UNITED STATES PATENT AND TRADEMARK OFFICE

APPLICATION NO.	FILING DATE	FIRST NAMED INVENTOR	ATTORNEY DOCKET NO.	CONFIRMATION NO.
10/825,407	04/14/2004	Keiji Ito	10873.1428US01	9378
23552	7590	04/07/2006	EXAMINER	
MERCHANT & GOULD PC P.O. BOX 2903 MINNEAPOLIS, MN 55402-0903			GOLUB, MARCIA A	
			ART UNIT	PAPER NUMBER
			2828

Office Action Summary	Application No. 10/825,407	Applicant(s) ITO ET AL.	
	Examiner Marcia A. Golub	Art Unit 2828

DETAILED ACTION

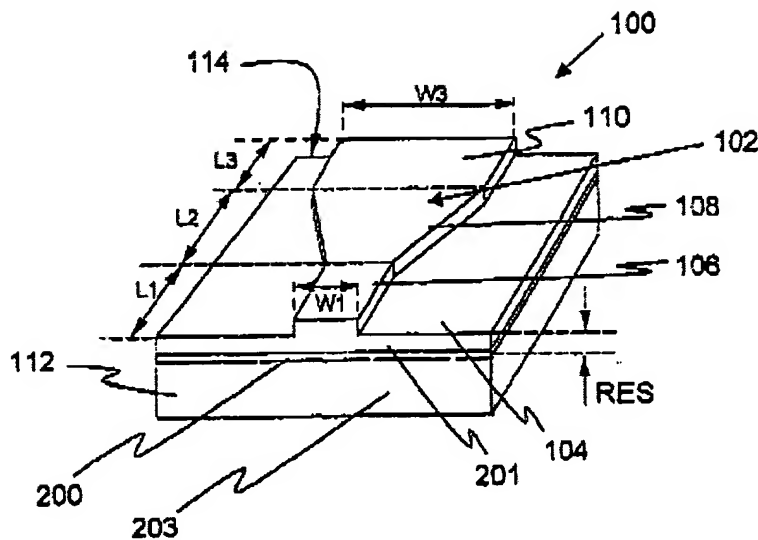
Claims 1, 3, 5, 6, 9-11 rejected under 35 U.S.C. 102(b) as being anticipated by Balsamo et al. (2003/0031222), hereinafter '222.

Regarding **claim 1**, Fig 1 of '222 discloses a semiconductor laser device, comprising:

“a first conductivity type cladding layer [203]; an active layer [200]; and a second conductivity type cladding layer [201], which are on a substrate [204],

wherein the semiconductor laser device further comprises a stripe structure [102] for injecting carriers therein,

a width of the stripe is wider at a front end face [W3] of a resonator [100] from which laser light is emitted than at a rear end face [W1] that is located on an opposite side of the front end face, (paragraph 0062)

and a reflectance of the front end face [114] is lower than a reflectance of the rear end face [112].” (paragraph 0062)

Regarding **claims 3, 5, 6, 9-11**, Fig 1 of '222 discloses a semiconductor laser device, comprising:

3. "wherein at least the active layer [200:200b, 200b] comprises an AlGaAs based semiconductor material (paragraph 0057);
5. "wherein a ratio between the stripe width [W3] at the front end face and the stripe width at the rear end face [W1] satisfies a relationship of $1 < (\text{the stripe width at the front end face}) / (\text{the stripe width at the rear end face}) < 2$ (for example: $W3=9$, $W1=5$ μm , $W3/W1=1.8$, paragraph 0023);

6. "wherein the ratio between the stripe width at the front end face and the stripe width at the rear end face satisfies a relationship of $1.4 < (\text{the stripe width at the front end face}) / (\text{the stripe width at the rear end face}) < 1.8$ (paragraph 0023);

9. "wherein the stripe structure has regions adjacent to the front end face [W3,L3] and the rear end face [W1,L1], the regions respectively extending inwardly from the front end face [114] and the rear end face [112] and each having a constant stripe width (paragraph 0062)

10. "wherein the regions having the constant stripe widths extend inwardly from the front end face and the rear end face, respectively, by a length of one-twentieth or shorter of a length of the resonator ($L1, L3 < L/20$); [$L3 > L/25$, $L1 < 16L/20$] (paragraphs 0024, 0026)

11. "wherein the reflectance of the front end face [85%] is lower than the reflectance of the rear end face [9%] by 15% or more." (paragraph 0062)

Regarding **claims 2 and 4**, Fig 1 of '222 discloses a semiconductor laser device, as disclosed above, but does not disclose:
